# Access Compliance Report

## Public Rights-of-Way

### (Curb Ramps)

Intersection ID: 6454	Main Street: BRYAN_FURR_DR	Cross Street: SLATER_SPRINGS_DR	Location: NW
ADA ID: 028F0531E725	Ramp Type: Perp	Initial Pass/Fail: Fail	Overall Compliance: No
		Severity Score: 22.5

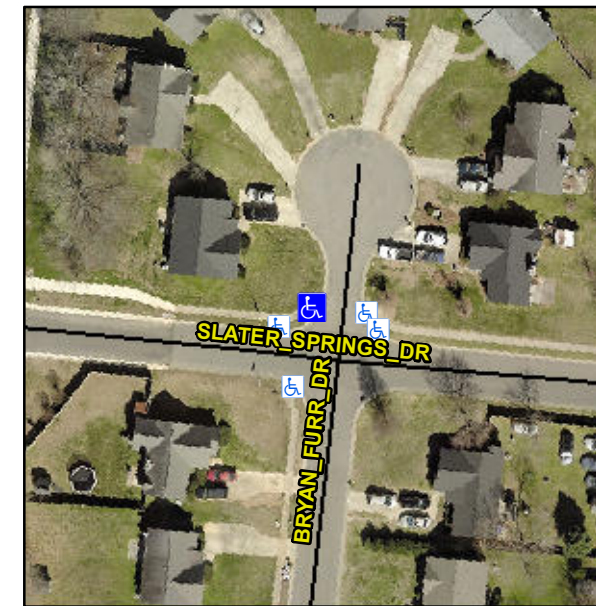
**Not Found, R304.5.1, R304.2.2, R304.5.3**

Compliance	Description	Data	Compliance	Description	Data
N/A	Ramp Length (in)	48.0	No	Ramp Slope (%)	8.6
No	Ramp Width (in)	42.0	No	Ramp XSlope (%)	2.3
N/A	Flare Type LT	N/A	N/A	Flare Type RT	N/A
N/A	Flare Slope LT (%)	N/A	N/A	Flare Slope RT (%)	N/A
N/A	Flare Traversable LT?	N/A	N/A	Flare Traversable RT?	N/A
N/A	Landing Length (in)	N/A	N/A	DWS Provided?	N/A
N/A	Landing Width (in)	N/A	N/A	DWS Contrast?	N/A
N/A	Landing Slope (%)	N/A	N/A	DWS Length (in)	N/A
N/A	Landing X Slope (%)	N/A	N/A	DWS Full Width?	N/A
N/A	Landing Curb? (Y/N)	N/A	N/A	DWS Offset (in)	N/A
N/A	Shared Landing?	N/A			
N/A	Gutter Ponding?	N/A	N/A	Gutter Slope (%)	N/A
N/A	Gutter Lip Ht (in)	N/A	N/A	Gutter X Slope (%)	N/A
N/A	Painted X Walk1?	No	N/A	Painted X Walk2?	N/A
	X Walk 1 Direction	To NE		X Walk 2 Direction	N/A
N/A	X Walk 1 Width (in)	N/A	N/A	X Walk 2 Width (in)	N/A
	X Walk 1 Slope (%)	2.6		X Walk 2 Slope (%)	N/A
	X Walk 1 X Slope (%)	3.3		X Walk 2 X Slope (%)	N/A

**Remove & Replace Entire Ramp.**
